HIDDEN CREEK ESTATES

A PORTION OF THE SOUTHEAST 1/4 OF SECTION 33, TOWNSHIP 11 SOUTH, RANGE 67 WEST OF THE 6th PRINCIPAL MERIDIAN, COUNTY OF EL PASO, STATE OF COLORADO.

Due to the number of comments in V2 there may be additional or new comments in V3.

SE 1/4 SECTION 33
FINAL PLAT
For:
JAMES HULL

8.4.2 Environmental Considerations

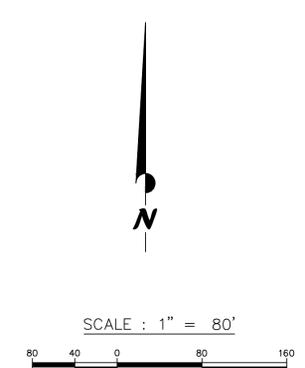
Unsuitable Building Areas. Areas within lots or tracts which reflect 1 or more of the following characteristics shall be deemed unsuitable for building and shall be identified as no build areas on the plat:
• Areas not suitable for location of water or sewage disposal systems as determined by State and County health regulations.

Identify areas not suitable for sewage disposal systems: "A Septic Suitability Map presented in Figure 5. It is recommended the areas labeled fw - floodway, indicating the FEMA Floodway and ss -steep slopes be avoided during the planning and placement of the OWTS' EPCPH agrees with RMGs OWTS Report show no build areas in the ss area shown in your OWTS report.

RESPONSE: The property owner is choosing to preserve a large area as no-build in order to preserve the natural beauty. The area outside of the floodplain is a suitable septic location per the OWTS report prepared by RMG. Septic systems may be constructed within the no-build area but not within the floodplain area. The lots are not overly constrained. See plat note regarding no-build vs. floodplain."

RESPONSE: "SS- steep slopes- moderate to steep slopes with slopes ranging between 12-24 percent. has been added. See Plat Note which allows for construction within the no-build areas. Septic systems may be constructed within the no-build area but not within the floodplain area. The lots are not overly constrained"
